SERVICE BULLETIN

MODEL BD-700-1A10 (BD-700)

**MODIFICATION – HORIZONTAL STABILIZER –
 ADDITION OF DRAINAGE HOLES TO ELIMINATE WATER ACCUMULATION AND
 ADDITION OF RIVETS ON THE ACCESS PANELS NUTPLATE ASSEMBLIES**

SERVICE BULLETIN: 700-55-004 **ISSUE:** Basic **DATED:** Jul 26/2002

KGC991-1094
Kit – Empennage Drainage Provisions
(Sheet 3 of 3, Rev. C)

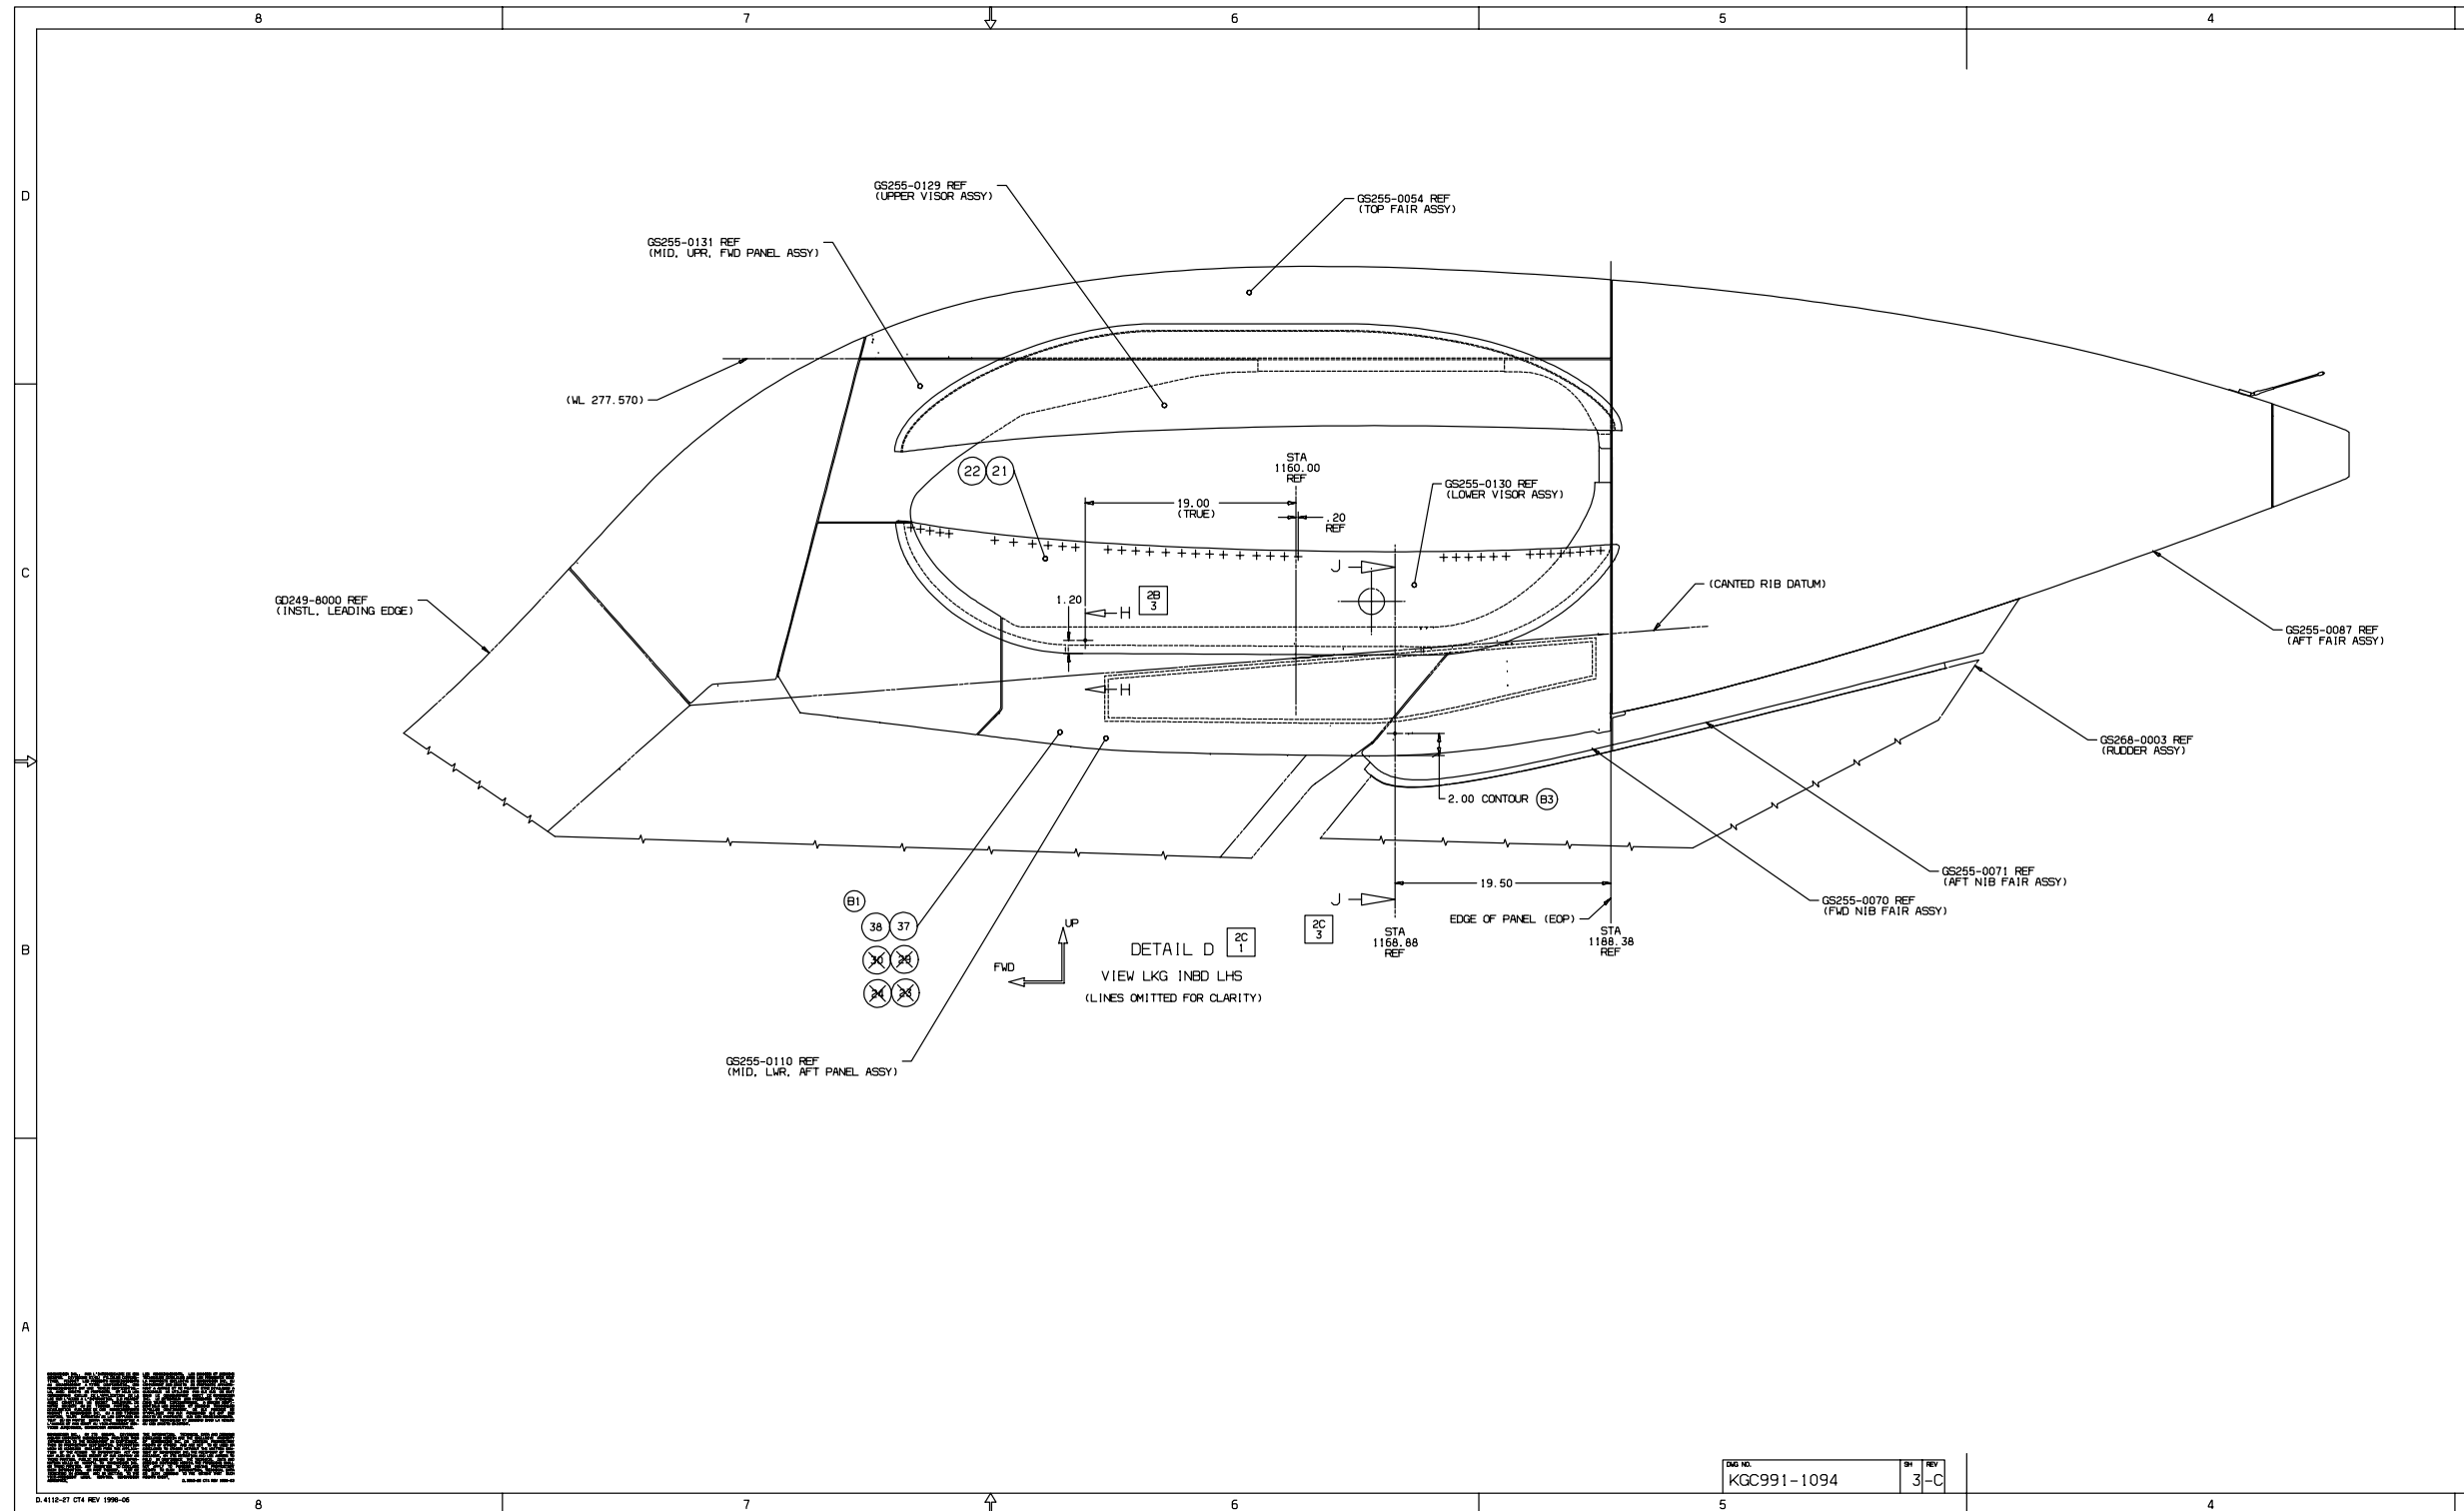
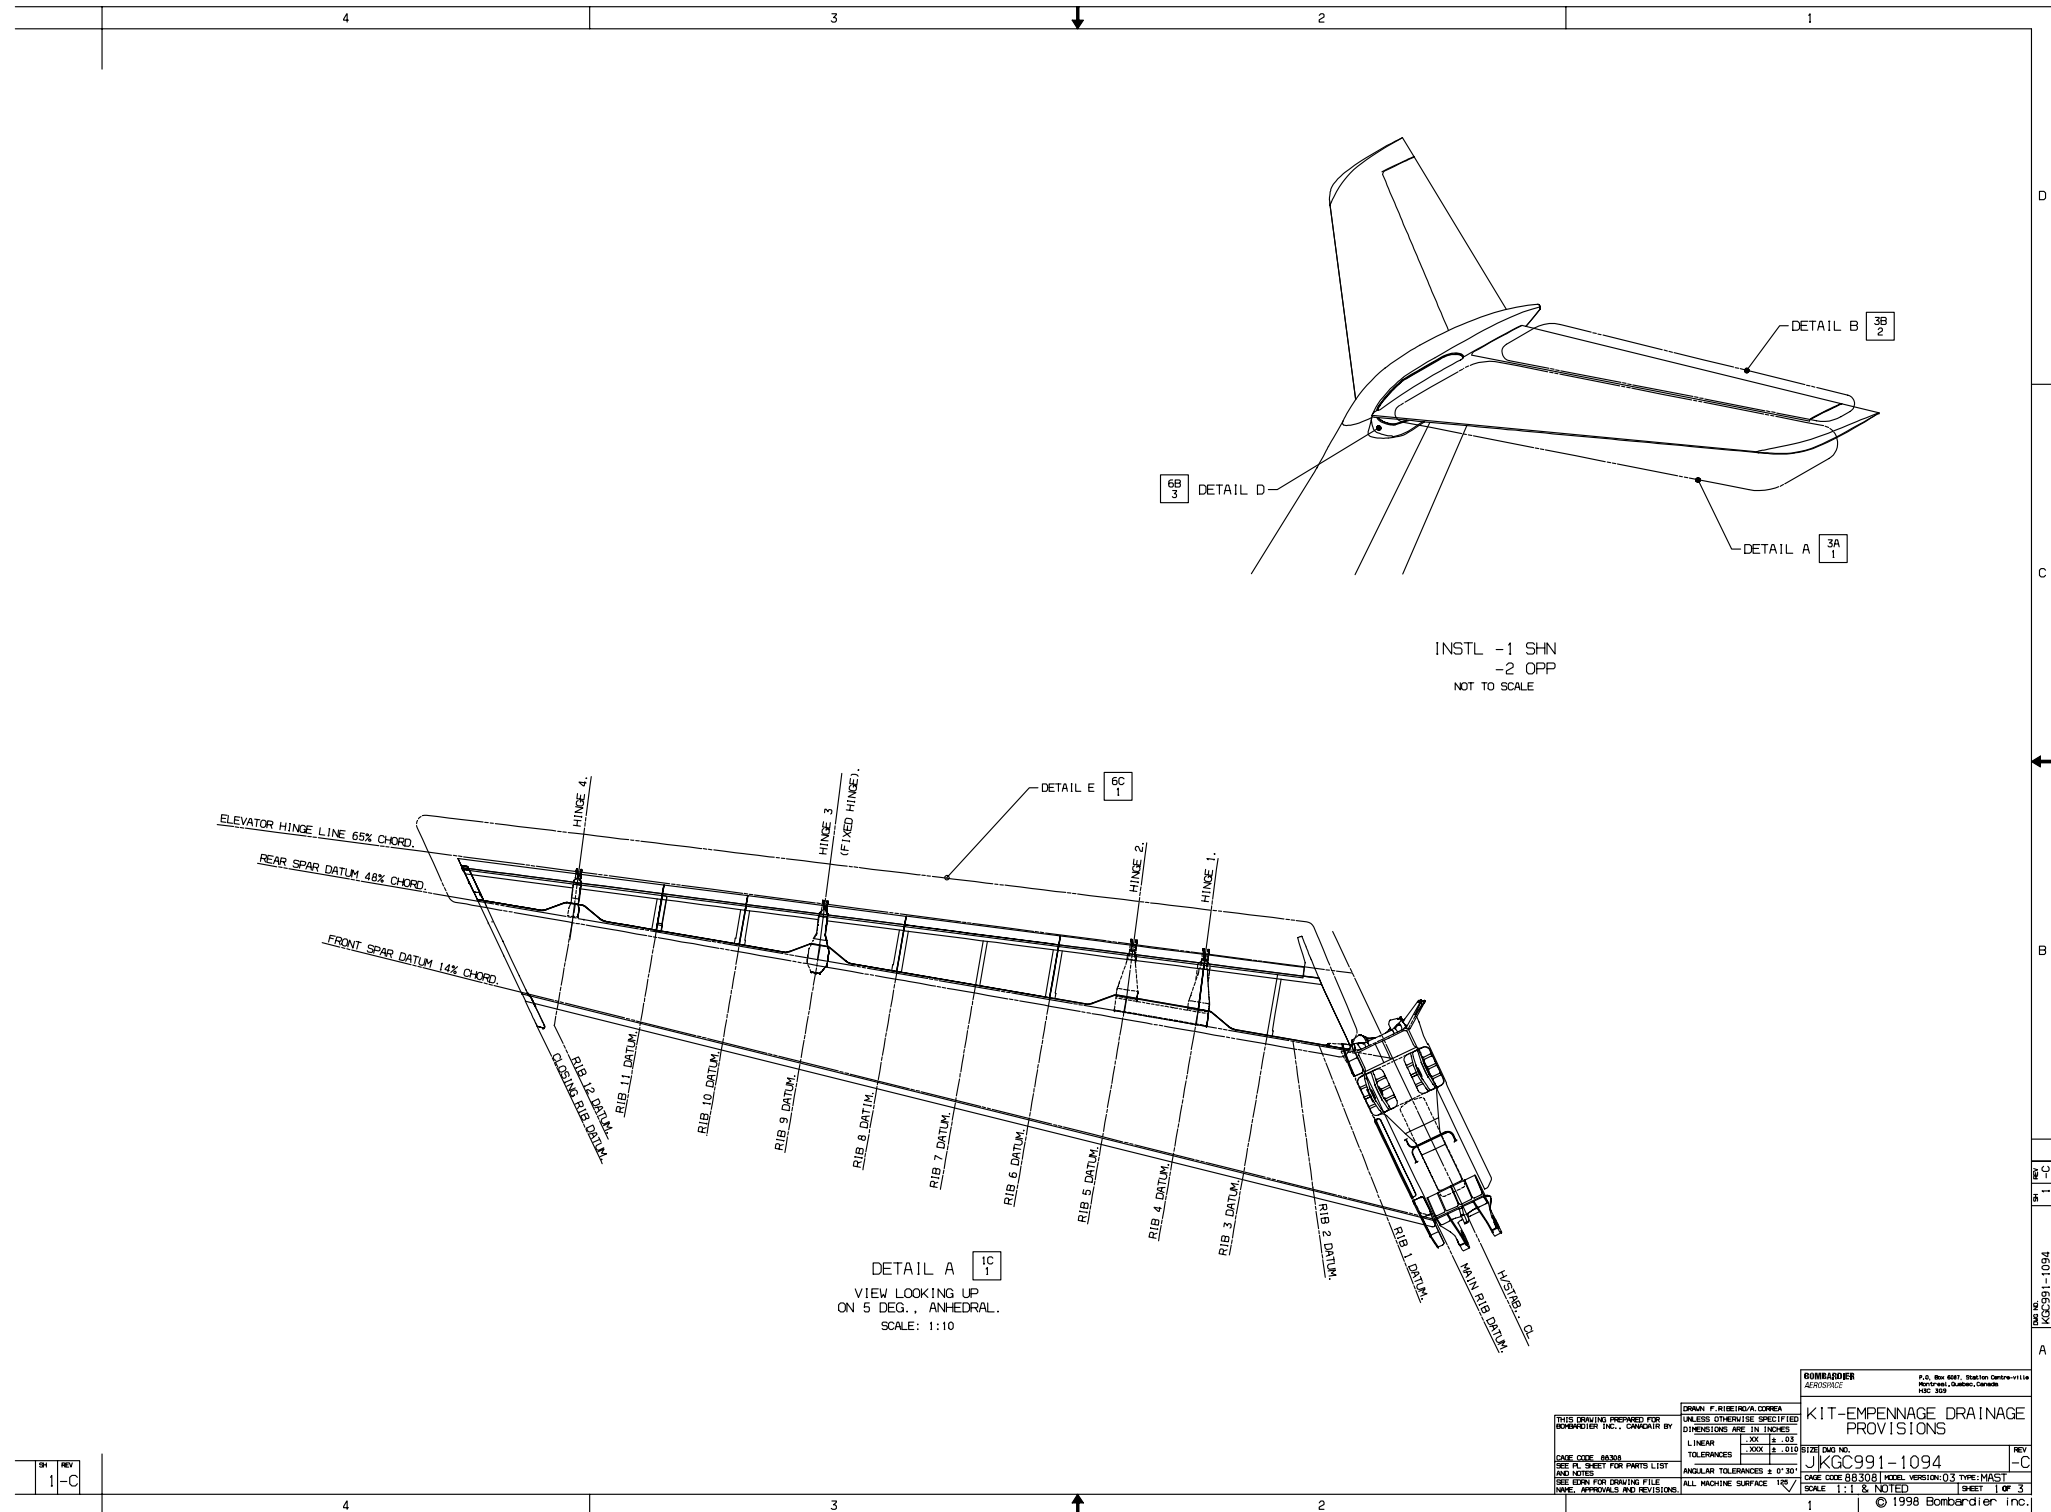
- NOTES:
1. 1 (ONE) KIT REQUIRED PER AIRCRAFT.
 2. SEAL HOLE PER BD700 SRM CHAPTER 51-34-08, USING FR3000 EPOXY COATING OR 50-A/9816 EPOCAST RESIN.
 3. IDENTIFY PARTS BY INK STAMPING PER BEST SHOP PRACTICES.
